工程變更客戶通知單

Engineering Change Customer Notification

ECR/ECN 單號： ECR/ECN Number:	ECR-19-8-134
日期： Date:	2019/11/15
變更者/郵箱： Author/Mail	Ruby Tseng rtseng@taoglas.com
客戶端工程變更需求確認：(signature) EC request confirmation by customer	請於 10 工作日內簽回，若超過 10 日未簽回將視為同意此變更 Please sign back within 10 working days, if you do not sign back within 10 working days, you will be deemed to agree to this change.
客戶端工程變更完成確認：(signature) EC completion confirmation by customer	請於 10 工作日內簽回，若超過 10 日未簽回將視為已確認 Please sign back within 10 working days, if you do not sign back within 10 working days, it will be deemed as confirmed.

產品類別 Product Category	零件編號 Part Number
CAB.S01 CAB.S02	CAB.S01 CAB.S02

Illustration of Change

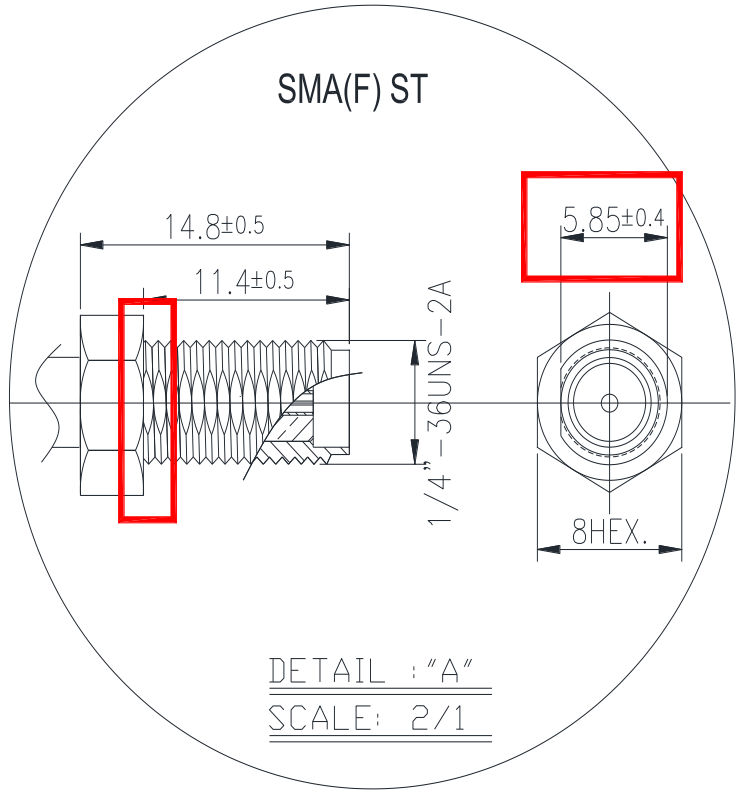
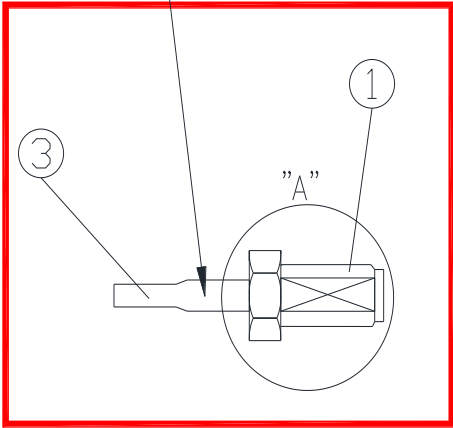
變更類型 Type of Change	<input checked="" type="checkbox"/> 工程設計變更 Engineering Design Change <input type="checkbox"/> 生產製程變更 Production Process improvement	
	<input type="checkbox"/> 其他: Others : Printing change	
變更原因 Reason for change	To avoid the rotation or slippage on connector.	
變更說明 Description of Change	1. Change the thread of connector to improve the locked force and strength of the customer's mechanism. 2. Change the heat shrink tube colour from black to white to show the difference of the previous production.	
變更影響 Impact of change	<input checked="" type="checkbox"/> 外觀 Appearance <input checked="" type="checkbox"/> 功能 Function <input checked="" type="checkbox"/> 規格 Specification <input type="checkbox"/> 品質 Quality <input type="checkbox"/> 可靠度 Reliability <input type="checkbox"/> 法規 Regulations <input type="checkbox"/> 包裝 Package: <input type="checkbox"/> 其他 Others:	
	上述影響描述: Describe if above applies :	Modify the connector's thread and the heat shrink tube colour .

Heat Shrink Tube Colour:Black

Heat Shrink Tube Colour:White
